Woodhaven Park Phase 2

DATE : May 17th, 2016

BID ADDENDUM NO. 1

Addition/Change to the Contract Documents

SHEET NO.	EC2
JOB NO.	SHR-13

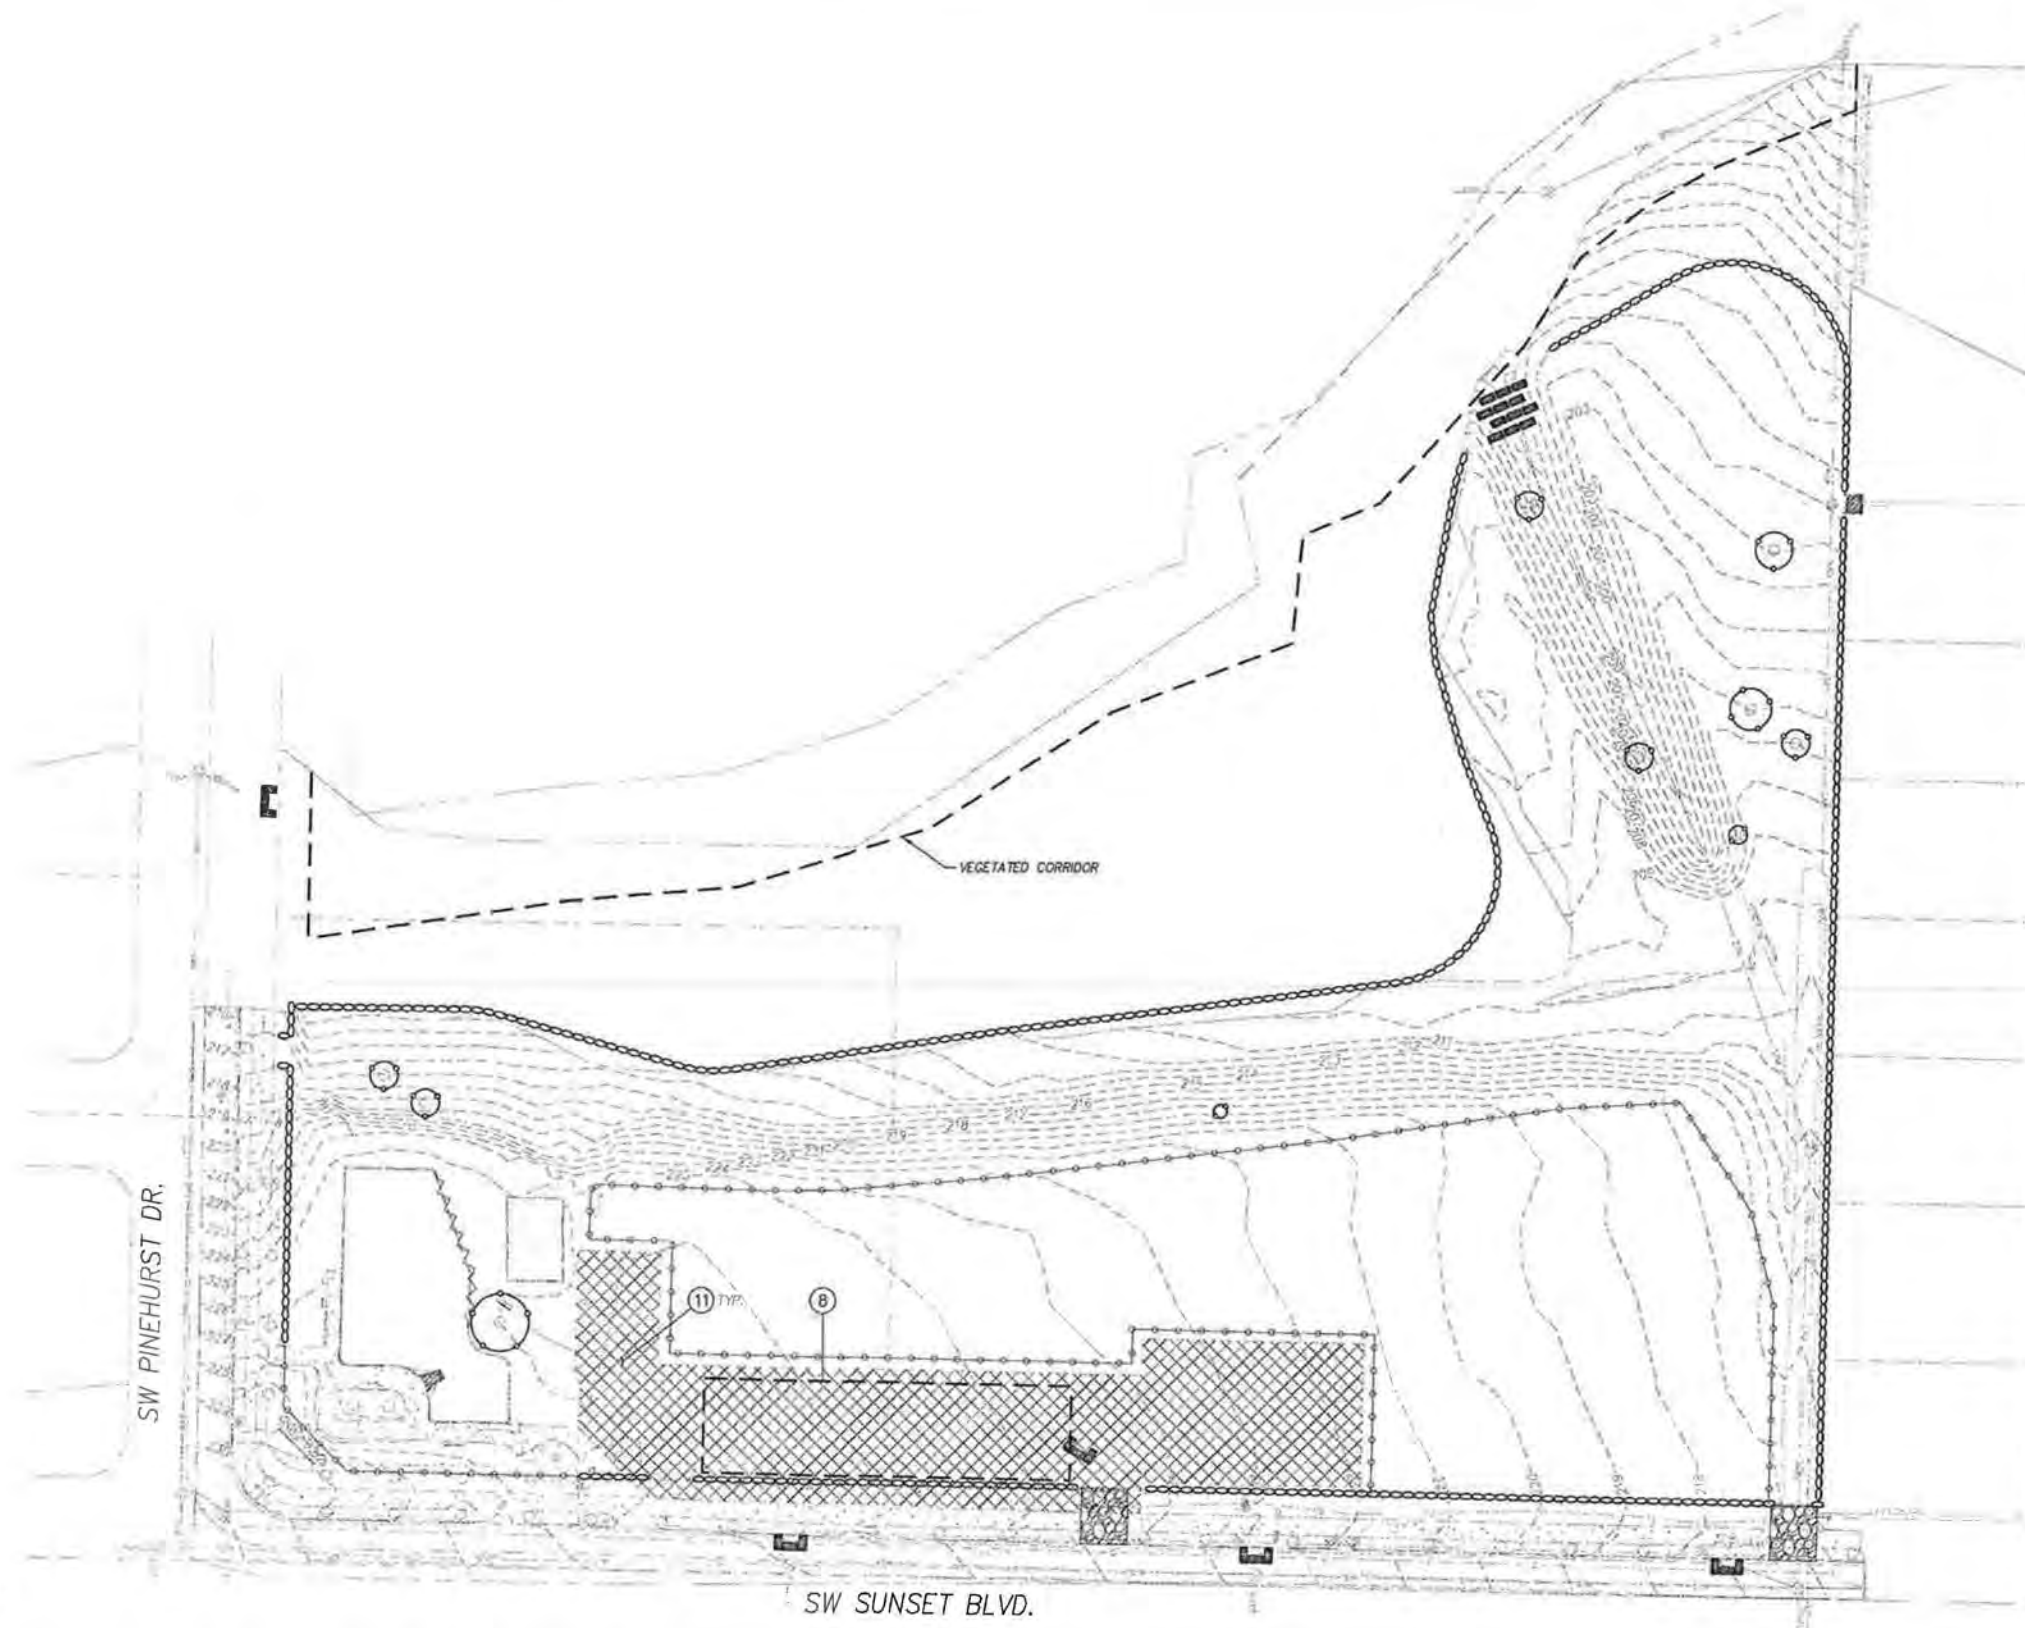
Sheet Number	Description of Change
EC2	Temporary Chainlink Fence Location to encompass the playground.
